# UNITED STATES PATENT AND TRADEMARK OFFICE

APPLICATION NO.	FILING DATE	FIRST NAMED INVENTOR	ATTORNEY DOCKET NO.	CONFIRMATION NO.
10/771,846	02/03/2004	Olaf Muller	7100-X04-025CIP (NEW)	9733
27317 7590 05/02/2007 FLEIT KAIN GIBBONS GUTMAN BONGINI & BIANCO 21355 EAST DIXIE HIGHWAY SUITE 115 MIAMI, FL 33180			EXAMINER CULBRETH, ERIC D	
			ART UNIT 3616	PAPER NUMBER
			MAIL DATE 05/02/2007	DELIVERY MODE PAPER

<b>Office Action Summary</b>	<b>Application No.</b>		<b>Applicant(s)</b>	
	10/771,846		MULLER, OLAF	
	<b>Examiner</b>		<b>Art Unit</b>	
	Eric Culbreth		3616

### Active safety steering column

Fig. 1

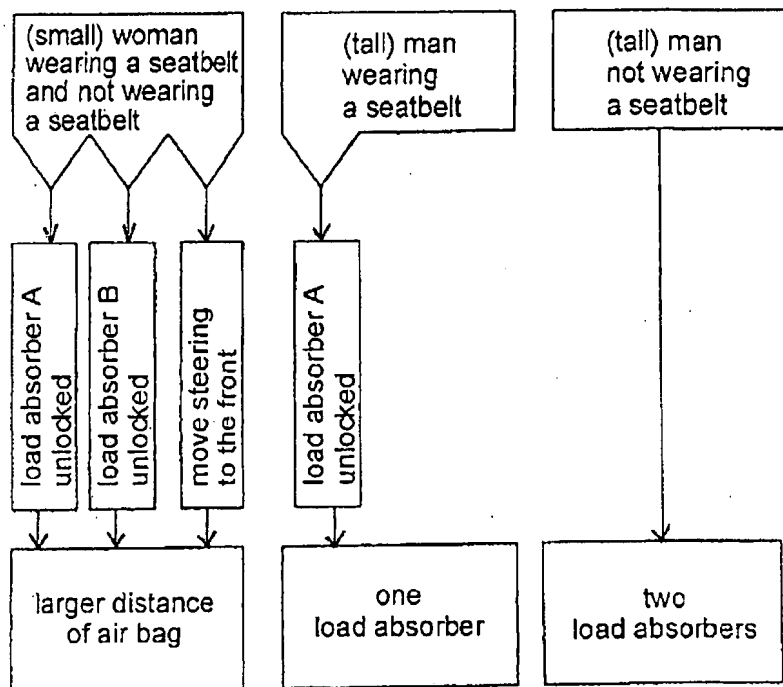
2. The drawings were received on 2/12/07. These drawings are approved.
3. The drawings are objected to under 37 CFR 1.83(a). The drawings must show every feature of the invention specified in the claims. Therefore, the material deforming bolts (claim 7), driver's size, weight and posture and height sensors (claims 8 and 27), and electrical and optical switch (claims 13-14 and 25-26) must be shown or the feature(s) canceled from the claim(s). No new matter should be entered.

Regarding applicant's remarks on 2/12/07, the bolts shown do not deform material (i.e., the recitation of "material deforming bolts" is a misnomer); Figure 2 does not show the claimed sensors, especially height and size sensors; electrical and optical switches are not shown in the drawings and do not appear to be even mentioned in the specification.

9. Claims 1-27, 38, 40-45, 47-54, 58-61, 64, 68 70-73, 77-81 and 83-86 are rejected under 35 U.S.C. 112, first paragraph, as failing to comply with the enablement requirement. The claim(s) contains subject matter which was not described in the specification in such a way as to enable one skilled in the art to which it pertains, or with which it is most nearly connected, to make and/or use the invention. Regarding paragraph 55, lines 1-4, it is not clear what igniting only the charge in bolt 11 will do. (Bolt 10 is closer to where deformation will occur in Figure 2). Applicant's remarks filed 2/12/07 do not clarify how destroying the bolt 11 will change the load absorbency over having the bolt there, since bolt 10 is closer to where the sheet of metal deforms. Since bolt 10 is closest to where the sheet of metal is being deformed, destroying a connection on the opposite side of bolt 10 (i.e., bolt 11) would not effect how the sheet absorbs energy.
